***VIRGINIA DEPARTMENT OF ENVIRONMENTAL QUALITY***

Re: Mountain Valley Pipeline, LLC (MVP)  
Erosion & Sediment Control (ESC) Plan Modification (2) Approvals

The Department of Environmental Quality (DEQ) hereby approves the following modifications to the Erosion & Sediment Control (ESC) Plan:

- MLV-23 and MVP-MLV-AR-23, Sheets 12.07ES and 12.08ES, Sign/Seal dated 8/14/2023, Sheet 12.08PC, Sign/Seal dated 12/7/2022.
- MLV29, H602/H-603 Tap Sites, Details 33.1-33.4, Sheet 14.34ES, Sign/Seal dated 3/30/2022, Sheets 15.78 ES, 15.91ES, Sign/Seal dated 5/5/2022 Sheets 15.92ES, 15.93ES, 14.34AES, Sign/Seal dated 8/14/2023.

DRAWN BY:	JW
CHECKED BY:	IHH
APPROVED BY:	DCW
DATE:	07/28/2023
SCALE:	AS SHOWN
SHT. NO. 15.93ES OF 15.99ES

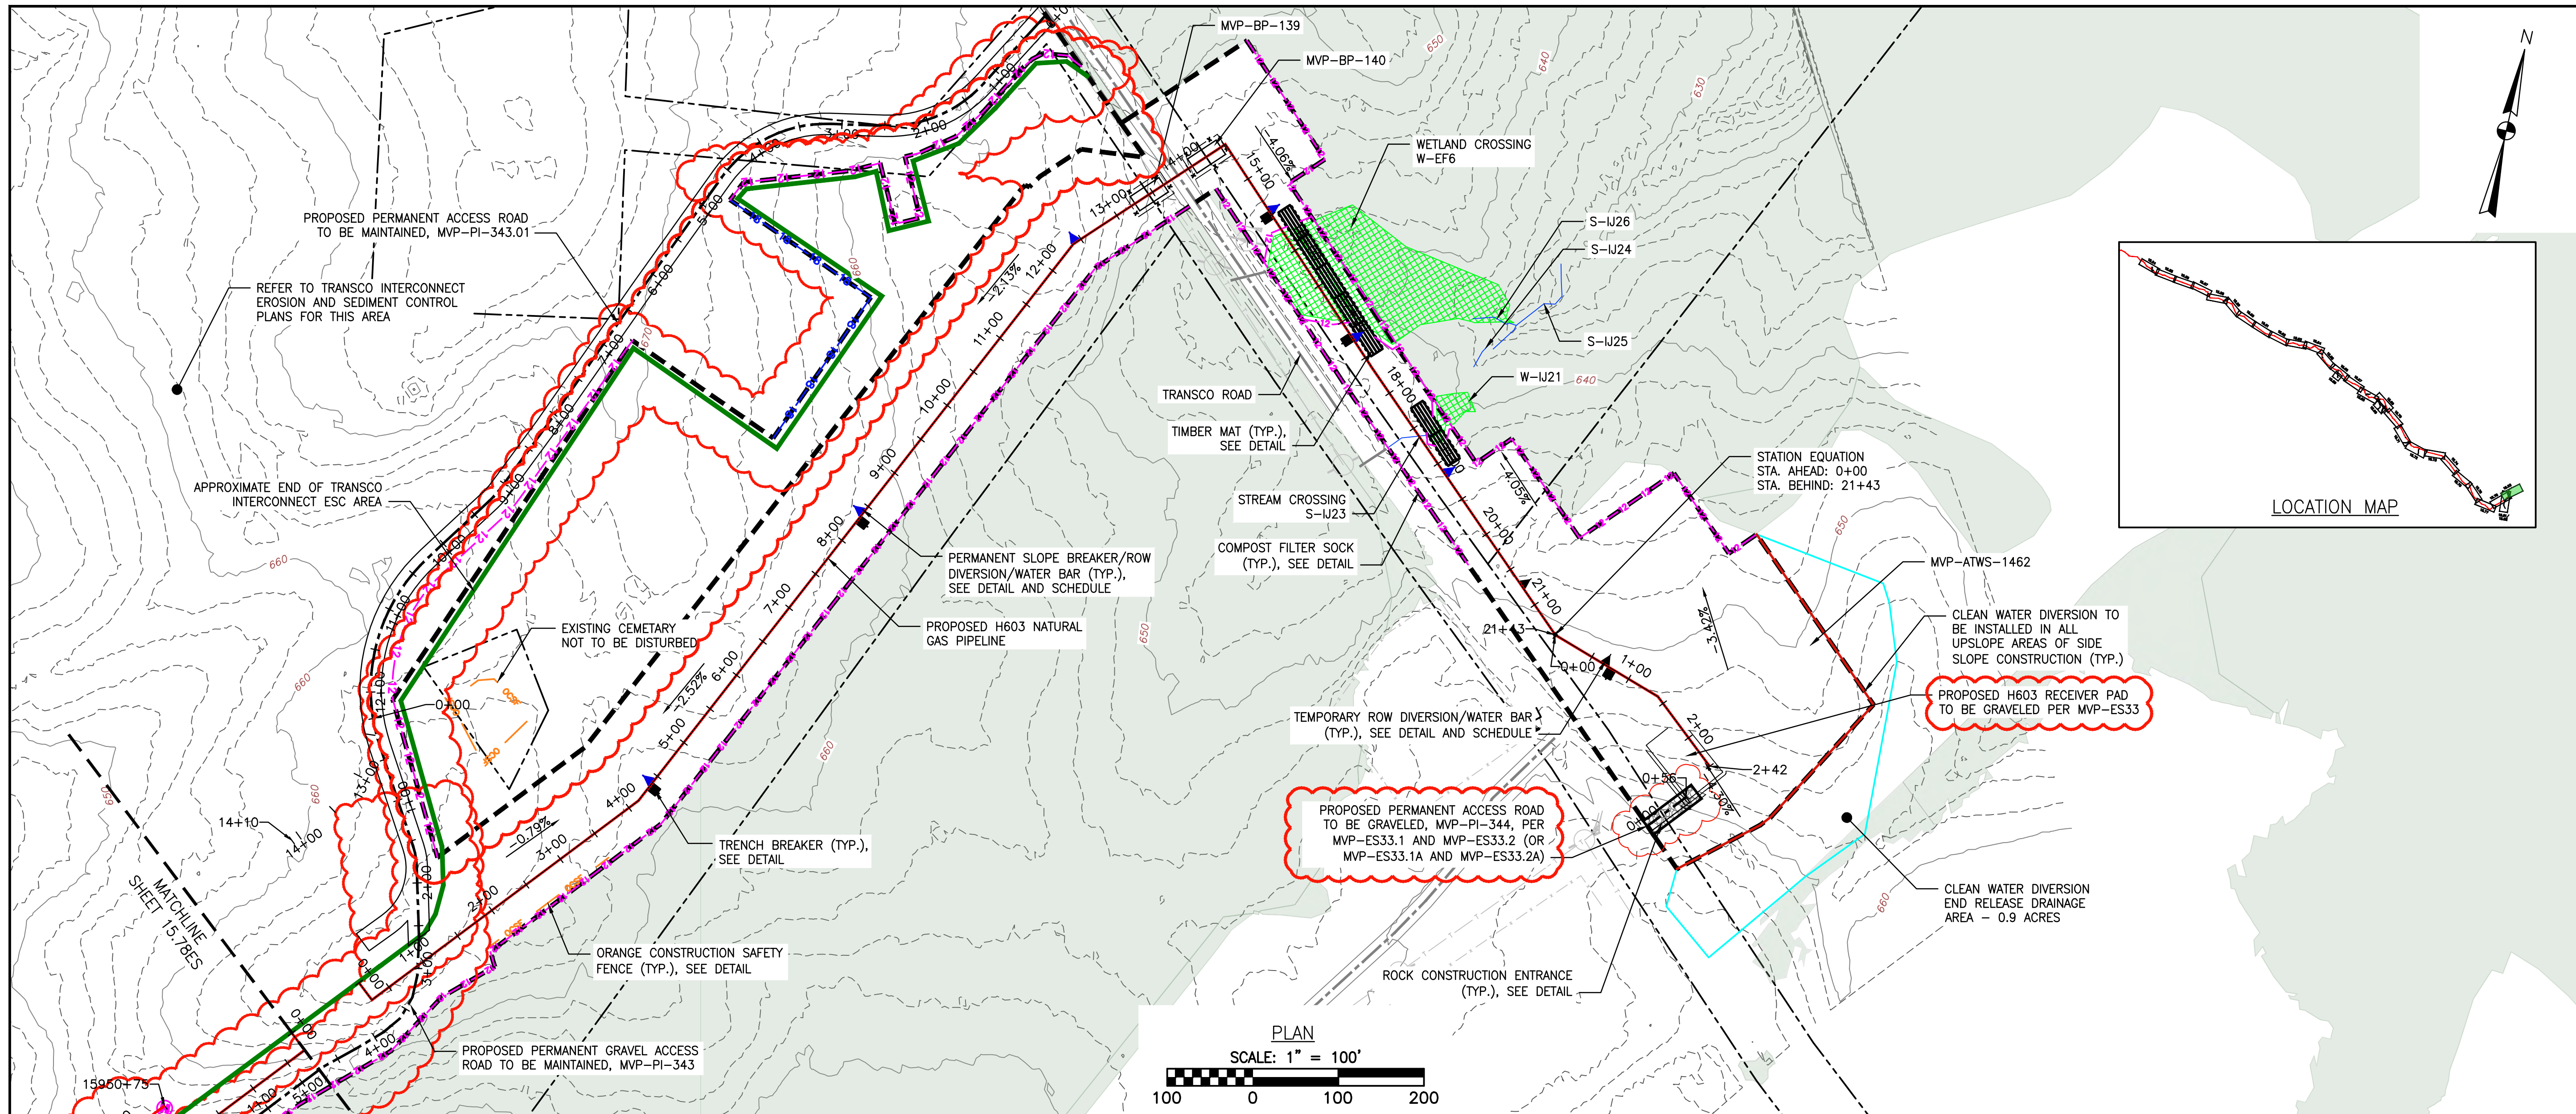
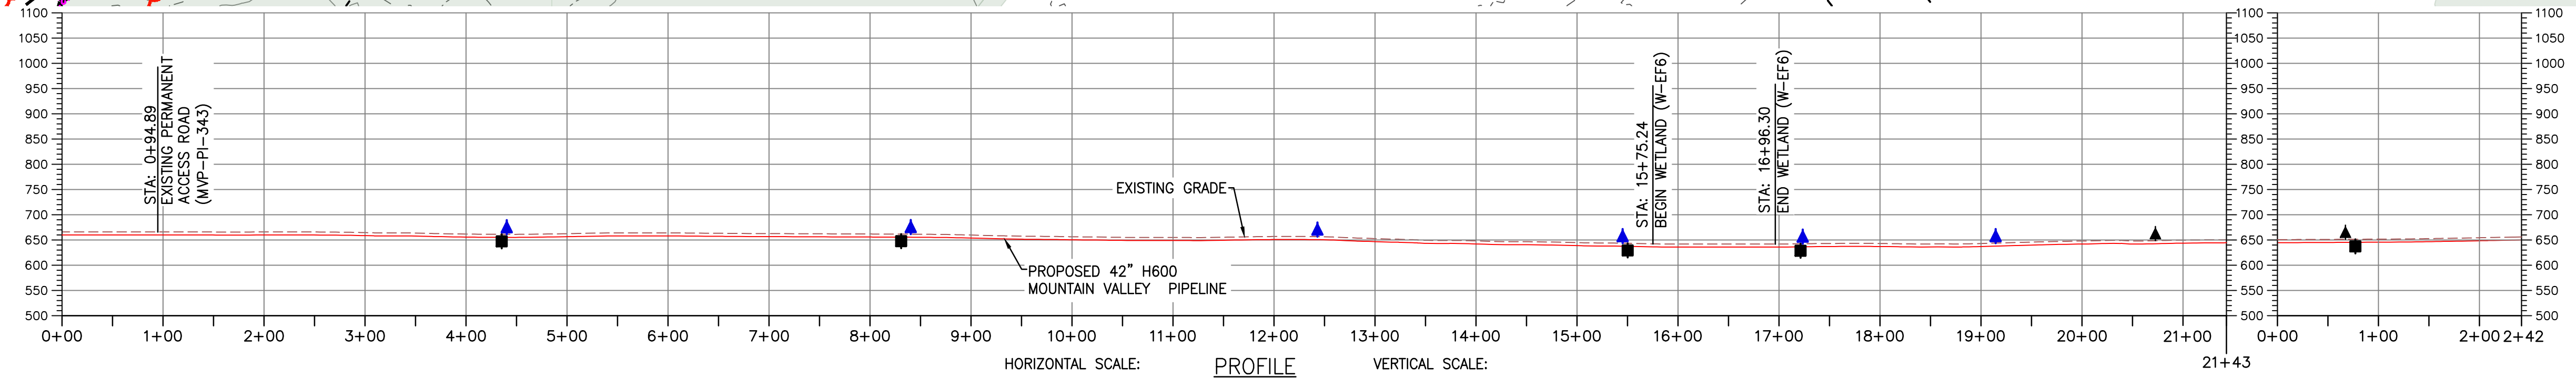
NO.	DATE	APPD.	CHKD.	DWN.	DESCRIPTION
1	07/28/23	JW	IHH	JW	ADDRESS VADEQ COMMENTS TO FIELD MODIFICATION SUBMITTAL
2	08/05/23	JW	IHH	JW	ADDRESS VADEQ COMMENTS TO FIELD MODIFICATION SUBMITTAL
3	08/22/19	JW	IHH	JW	ADDRESS VADEQ COMMENTS TO FIELD MODIFICATION SUBMITTAL
4	04/18/19	JW	IHH	JW	ADDRESS VADEQ COMMENTS TO FIELD MODIFICATION SUBMITTAL
5	01/21/19	JW	IHH	JW	FIELD MODIFICATION-UP 30.3 (WRC RECEIVER SEE AND ACCESS ROAD (MVP-PI-343))
6	03/16/18	KAL	IHH	JW	ADDRESS VADEQ COMMENTS
